Proposed amendment to Appendix 11 to the GCU

Title	High voltage warning signs (Stop!)
Proposed amendment made by: RU/keeper/other:	GCU Joint Committee ad hoc working group meeting chaired by UIC on 15 March 2021
Proposed amendment to:	<input type="checkbox"/> Appendix 9 <input checked="" type="checkbox"/> Appendix 11
Proposer:	Jean-Marc Blondé
Location, date:	Olten, 16/03/2021
Description:	Two pictograms for high voltage warnings are documented in Appendix 11. The exact scope of application for the second (“Stop!”) warning sign is not regulated precisely. The definition proposed here will resolve this issue and will accomplish precise regulation.

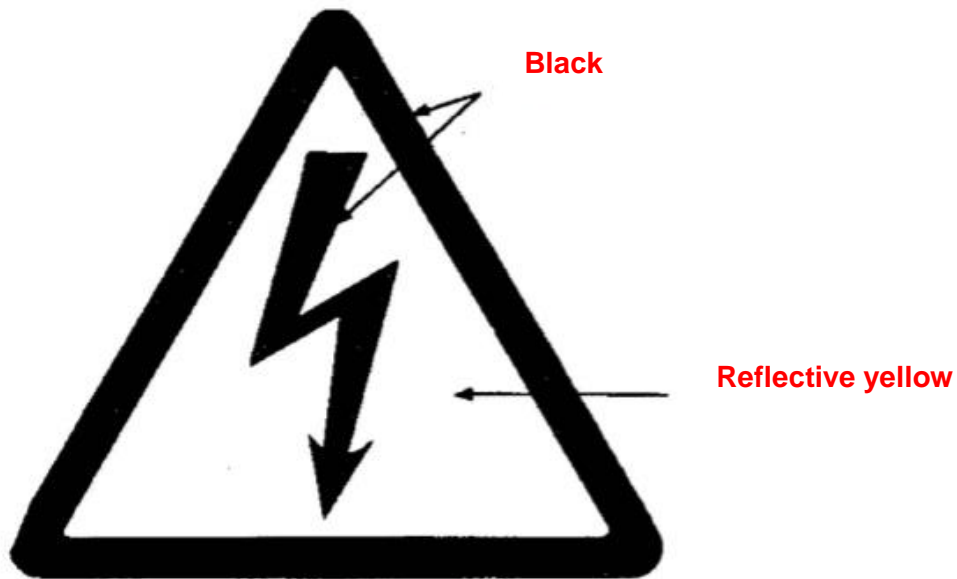
Add the second "Stop!" pictogram to a new point 8.2, GCU Appendix 11, defining what is meant by "wagons whose design enables them to be climbed" and indicating that the pictogram with the lightning flash is not necessary for this category of wagon.

3. Amendments/additional text (relates only to proposed amendments to GCU Appendix 11):

Amendment colour code:

Black: Current text, for info and remains unchanged

Red: New text

Blue (if crossed out): text to be deleted

8.2 Signs for high voltage warning sign (Stop!)

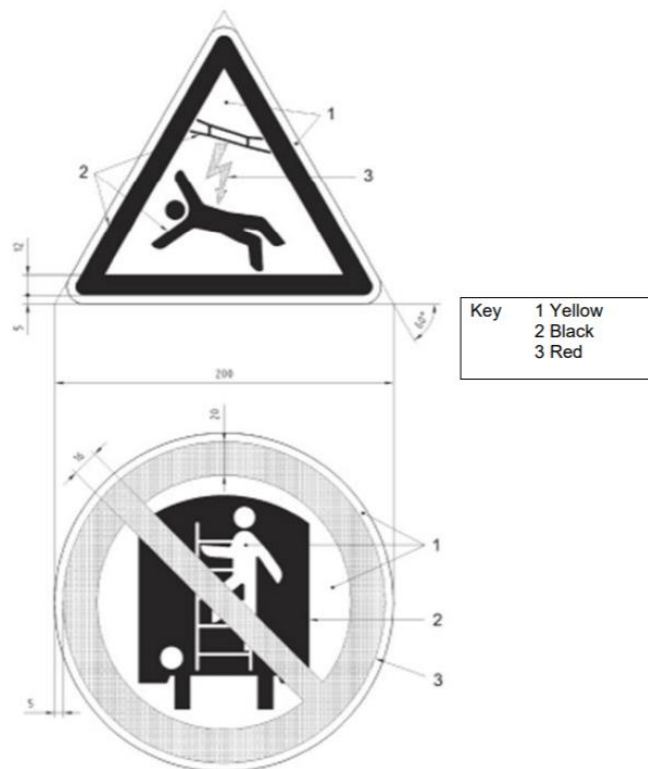
- Position:** On wagons with steps or ladders, in the immediate vicinity of these fittings and at a height such that the sign is visible before the danger zone is reached. For use on wagons where the top step or upper part of the ladder is more than 2.0 m above rail level, or whose design enables them to be climbed. This pictogram may be shown on a rectangular blue background measuring 400 mm x 220 mm.
- Meaning:** Warning - high voltage. Stop! You are entering a particularly dangerous area. Only duly authorised personnel may work in this area having first taken the necessary precautions.
- Remark:** This marking is mandatory as of 1/1/2021.

Wagons whose design enables them to be climbed fulfil two criteria:

1. The external part of the end walls is fitted with horizontal elements with a maximum vertical distance of 45 cm.
2. These elements must be at least 5 cm in depth or must be comparable to steps of a ladder.

If both criteria are fulfilled, the pictogram in 8.2, “Signs for high voltage warning sign (Stop!)” must be affixed, but the pictogram in 8.1, “Sign for high voltage warning sign (lightning flash)” is not required.

Both warning pictograms (8.1 and 8.2) must be affixed on wagons equipped with ladders and steps.
